Ngā Ūranga ki Pito-One Shared Path

30% Detailed Design

5 September 2022

Figure 2: Example of the existing layout with visual delineation demarcating the pedestrian and cycle movements

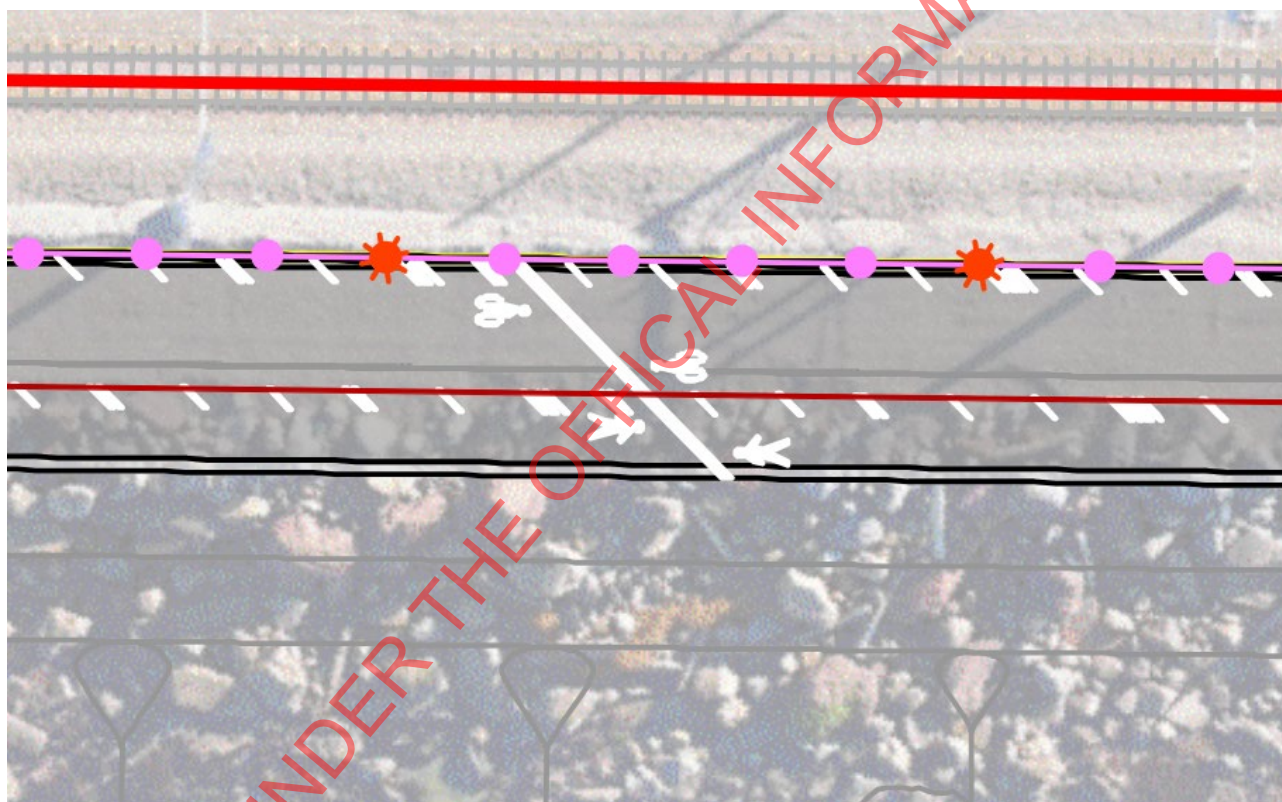
The pathway width is proposed at 4-5m which will accommodate general movements for people walking, cycling, passing and riding/ walking in pairs. The pathway should be able to provide adequate space for peak flow cyclists during the work week. However, at the weekend, users will likely be more sporadic and could typically be groups or families riding together. This creates a need for greater space for passing manoeuvres.

The preliminary drawings identify the pathway will be split with visual cues provided to demarcate separation between people walking and people cycling. During the project briefing the design team highlighted that a delineation strip was being provided to provide the visual separation, however, material choice has not yet been confirmed. It is conceptually shown as a directional tactile paver with painted hatching (or similar) which will provide a colour and texture difference.

The proposed pathway width could present risks of groups of walkers 3-4 abreast overlapping the cyclepath and may cause friction with cyclists as they protrude into the cycle path.

It is recommended that an option to provide a full, shared path with no delineation along with behavioural influencing signage and marking to reduce friction between users.

Figure 3 Uranga layout requires further demarcation of movement vs. seating areas

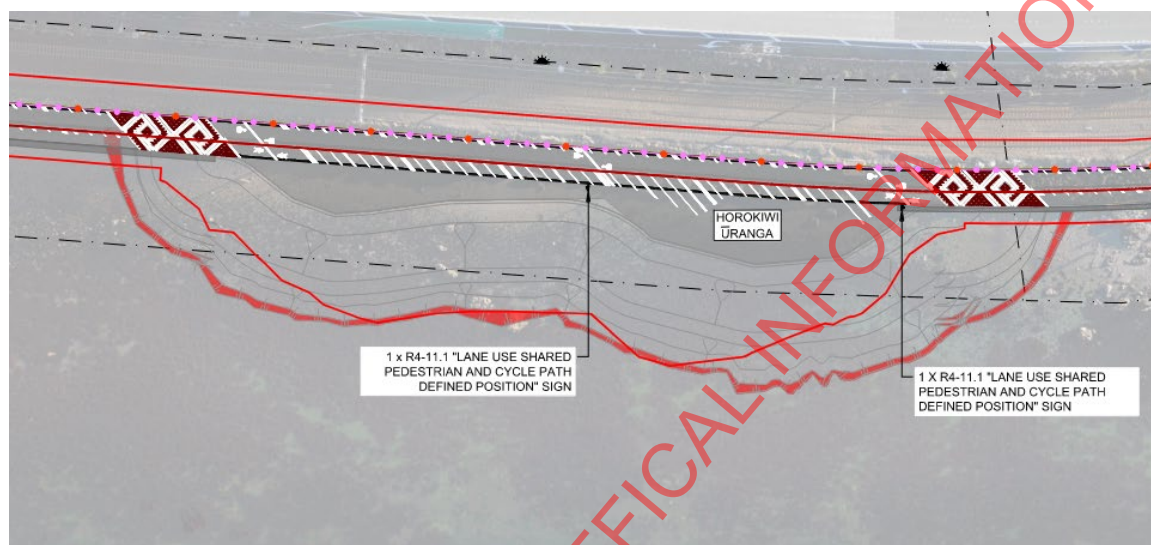
There are 6 proposed Uranga sites spread along the route which provide great amenity for path users. These areas provide seating, lookout and artwork which tell a story of the place. This will enhance the journey experience and enable people to stop, rest and gain knowledge before continuing along the route. Due to the length of the route the safety audit team questioned whether there were opportunities to integrate more secondary pause points (ie. Seating/ small stopping areas) to allow further opportunities for people to stop and rest along the journey. These sites will also be very popular destinations at the weekends for recreational users and require adequate space for movement as well as passive recreation.

Some Uranga sites are larger and have the ability to accommodate a walkway that is separate from the main shared path. This will provide relief from cyclists for pedestrians and enhance the separation of the modes.

Proposed Uranga layouts should be considered to ensure people walking and cycling can easily access these rest areas. This includes placing bike racks away from main access points and allowing for a clear differentiation between movement paths and passive zones through the area.

Figure 5 Circled intersection for wayfinding required to enable clear directions for path users

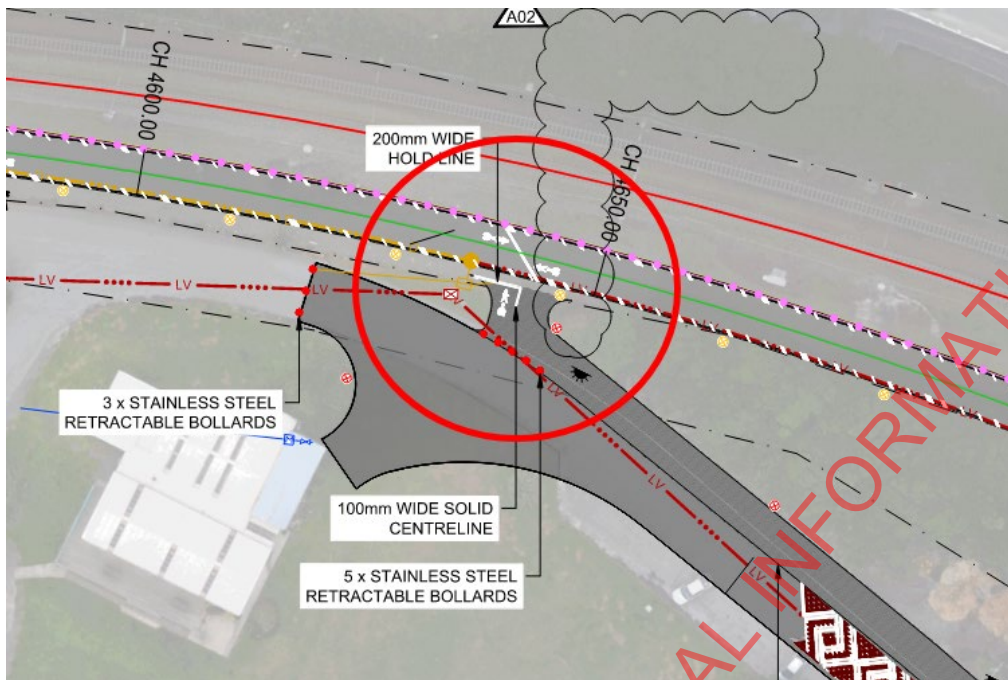
There is no wayfinding signage indicated on the plans. Consider providing wayfinding signage, map boards and signs highlighting distance to key destinations. A critical area for wayfinding includes at the Y junction in the shared path to both Hōniana Te Puni Reserve and Hutt Road.

Figure 6 KiwiRail Maintenance Bay located at CH2950m

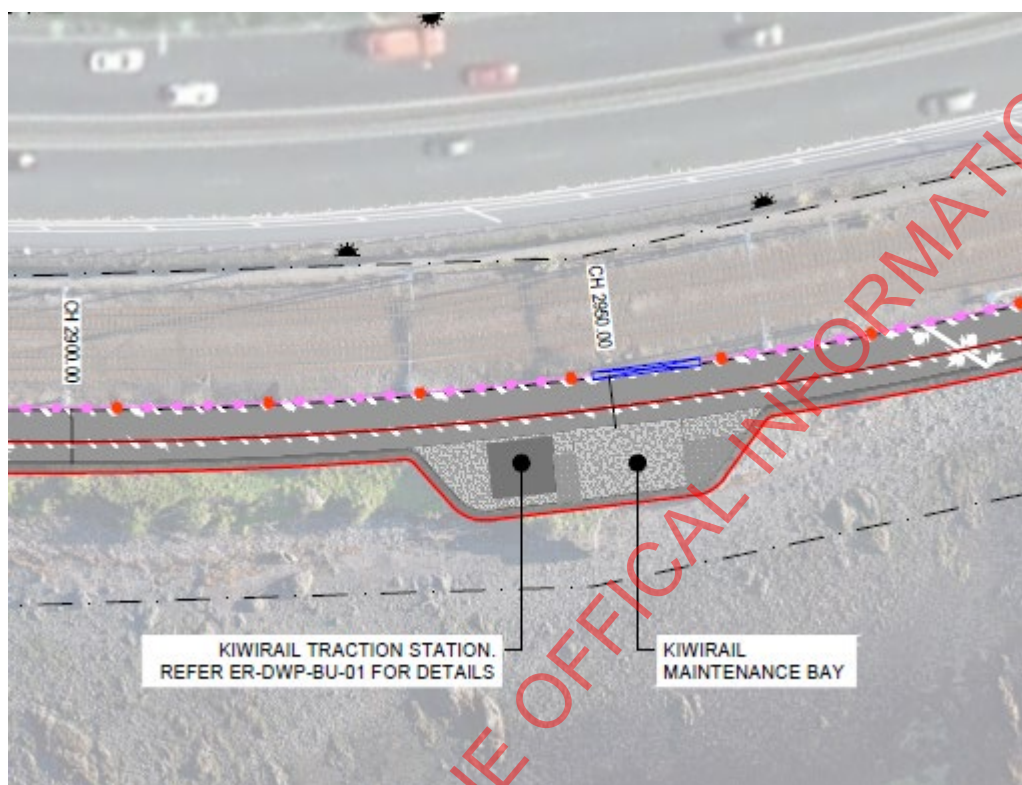
The existing KiwiRail Traction station shows a maintenance bay where vehicles are likely to park up during times of maintenance. This may cause conflict with shared path users.

Install appropriate warning signage and markings for both shared path users and KiwiRail staff. Implement a Health and Safety protocol for all KiwiRail Staff the entire length of the shared path for maintenance purposes. The adjacent KiwiRail access gate should remain locked at all times and regularly checked that it is so.

Figure 7 Maintenance Bay located at CH880m

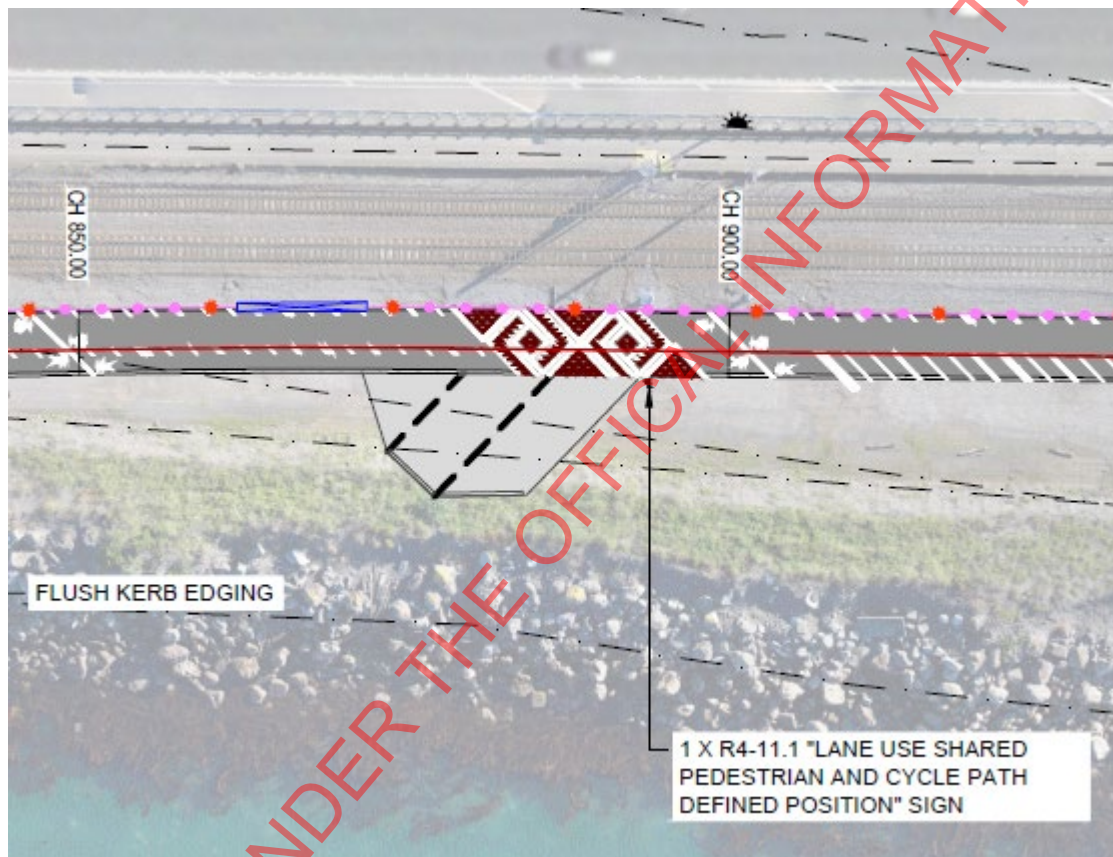
There are a number of maintenance bays for maintenance vehicles to park along the route. These areas have the potential to cause conflicts between vehicles and shared path users

Install appropriate warning signage and markings for both shared path users and maintenance bay users. Implement a Health and Safety protocol for all maintenance crews for the entire length of the shared path for maintenance purposes. The adjacent KiwiRail access gate should remain locked at all times and regularly checked that it is so. This should be the case for all KiwiRail access gates along the route.

Figure 9: Cyclepath crossing over KiwiRail Access Lane.

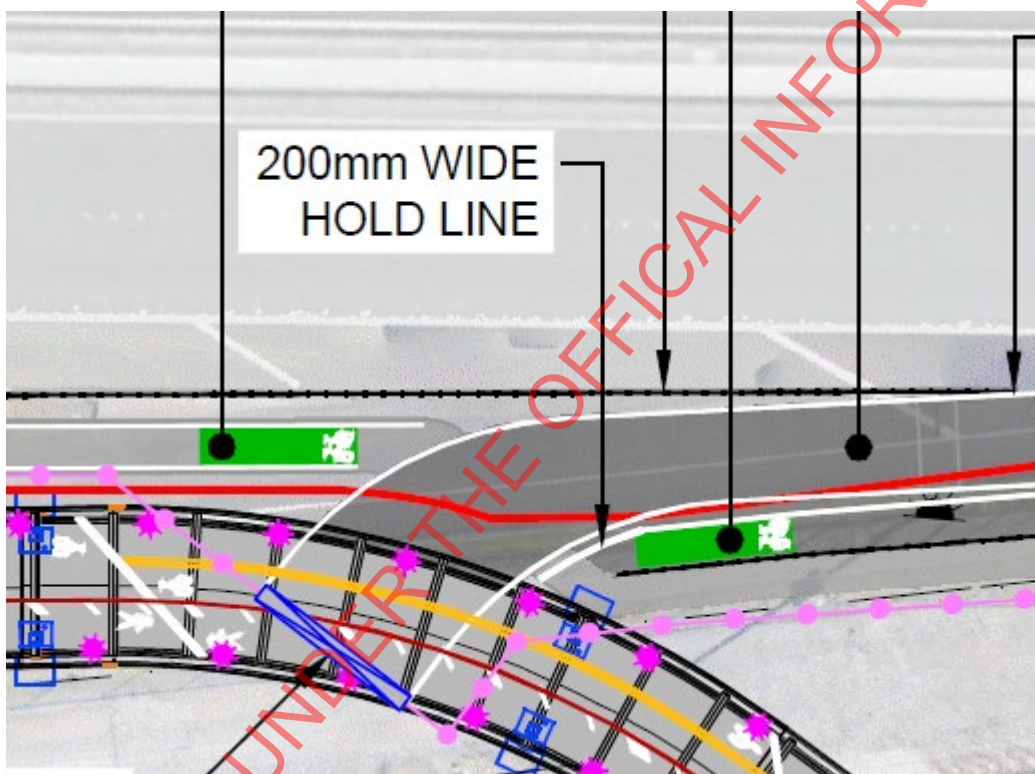
The access from the SH2 shows a formal cycleway with green markings which crosses the KiwiRail access lane. This may tend to encourage cyclists (especially the high speed cyclists) not to use the new shared path and to use the SH2 shoulder all the way from Petone to Ngauranga. We believe that this access should be a last resort only cyclepath and only if cyclists find themselves on SH2 and need to exit.

- that this access from the shoulder be a subtle (i.e. last resort) exit.
- Include appropriate signage installed at the Northern end of SH2 that encourages all cyclists to use the shared path and not SH2 as well as appropriate signage to indicate to any cyclists on SH2 that they must exit at this location before going onto the Thorndon Quay raised motorway.
- Include appropriate design elements to avoid conflict between KiwiRail users and cyclists such as giveway and warning signage and markings.
- It is recommended that the movement path for cyclists across the access lane should be at 90 degrees to the vehicle movements. An example of this layout is shown in Figure 9.

Figure12: Area where there is opportunity to separate the shared path from the access lane.

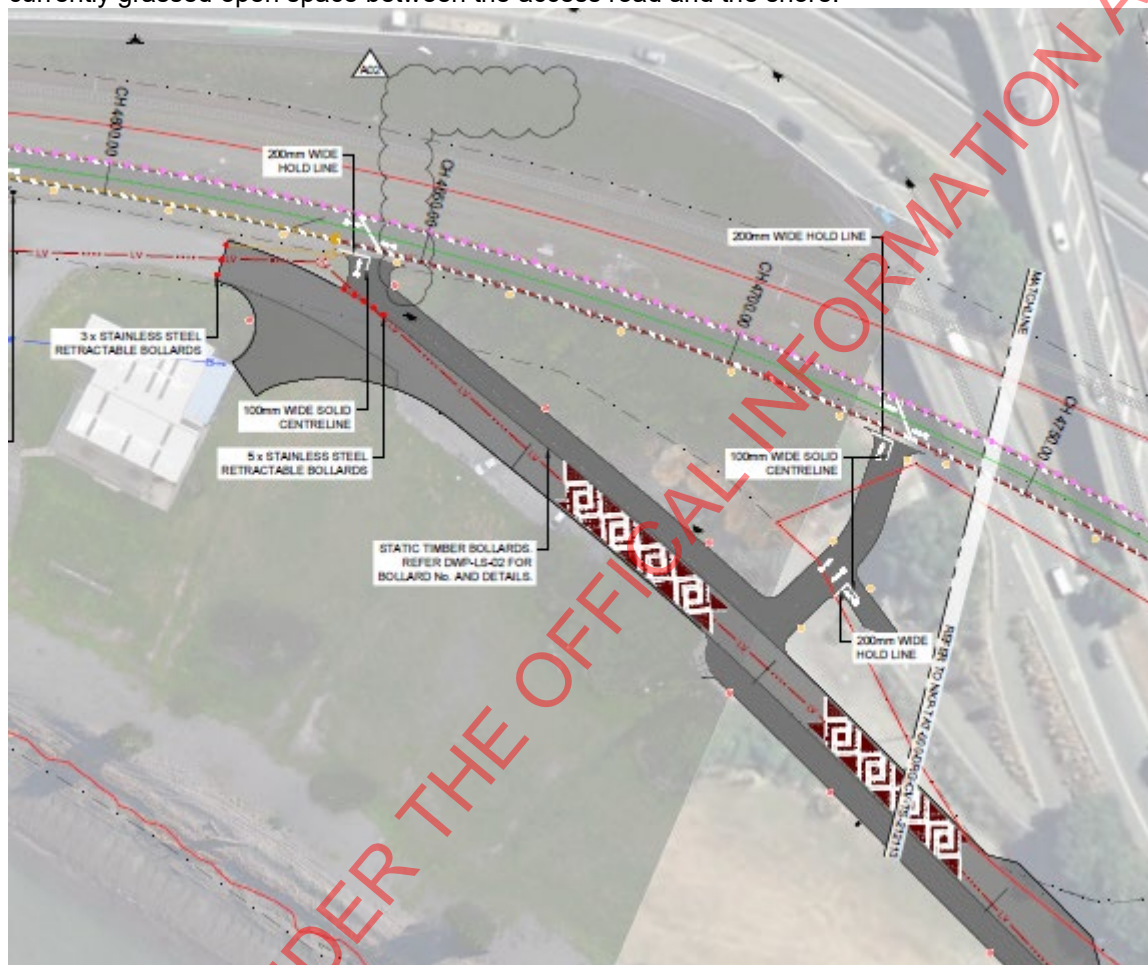
The shared path has been designed hard against the Access Road to the Water Ski club in the area to the west of the Korokoro bridge and South of the Water Ski Club Buildings. However, there is opportunity here to fully separate the shared path from the access road by creating a meandering path through the large currently grassed open space between the access road and the shore.

Separate the shared path from the access lane through this large open space area. There is also an opportunity in this area to separate the cyclists from the pedestrians. Possibly consider a separate bridge for the shared path users also to further increase safety measures.

Figure 14: Boat Ramp area with very limited turning space.

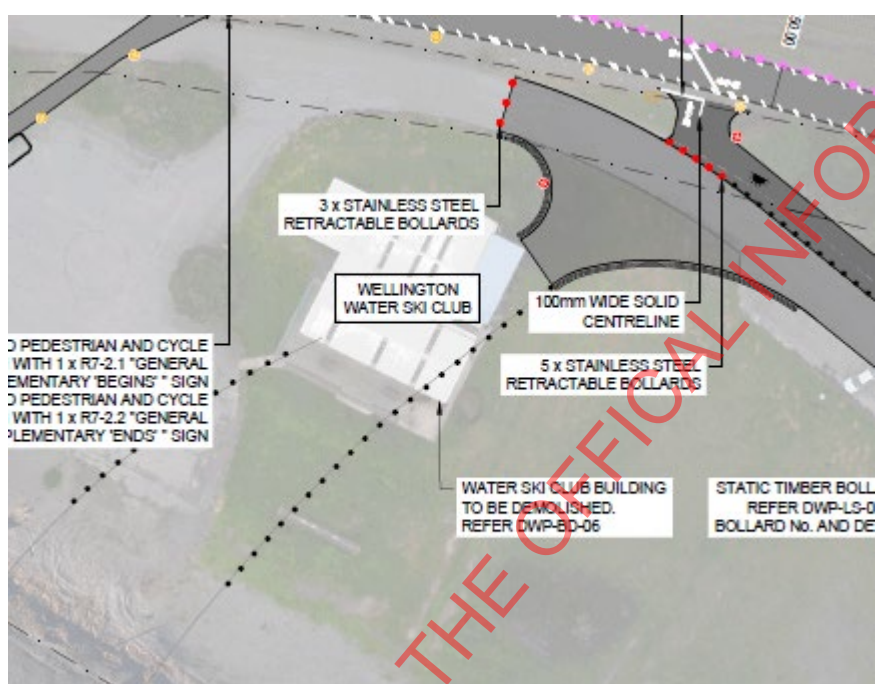
The proposed boat ramp access appears to have limited area for car and trailers to make turning and reversing manoeuvres. Vehicles with boat trailers (especially rowing skiffs) require large amounts of turning space to access the boat ramp. Providing a reduced area for manoeuvring could create issues with conflict with other vehicles and shared path users.

Consider the design and layout of the boat ramp access and provide sufficient turning areas for vehicles and boat trailers / staging areas. Consider long skiff trailers when designing the area.

Figure 16: Shared path crossing at boat access road

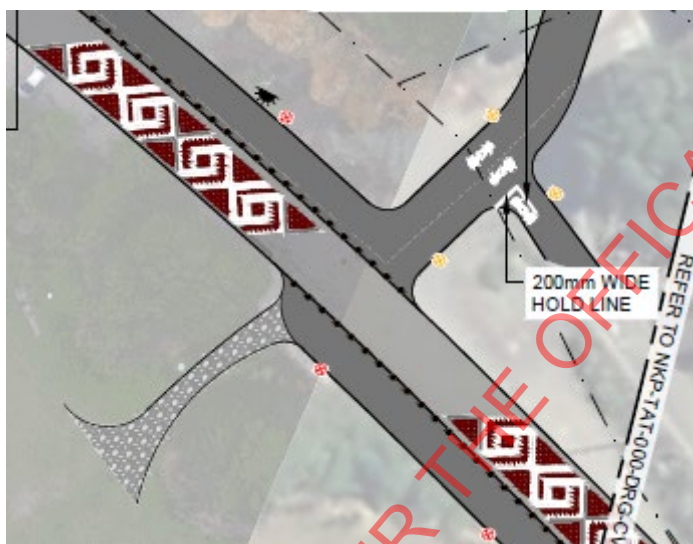
This area is a conflict zone with the different users including vehicles on the access lane, cyclists and walkers on the hazard path and other users within the park area itself. This area has potential to cause collisions between all the users.

Provide traffic calming measures and bollard placement to enable a seamless journey for both pedestrians and cyclists. It is recommended that the option is explored to include a raised platform across the access road to retain the shared path at one level. A raised platform will also encourage slower speeds by car drivers.
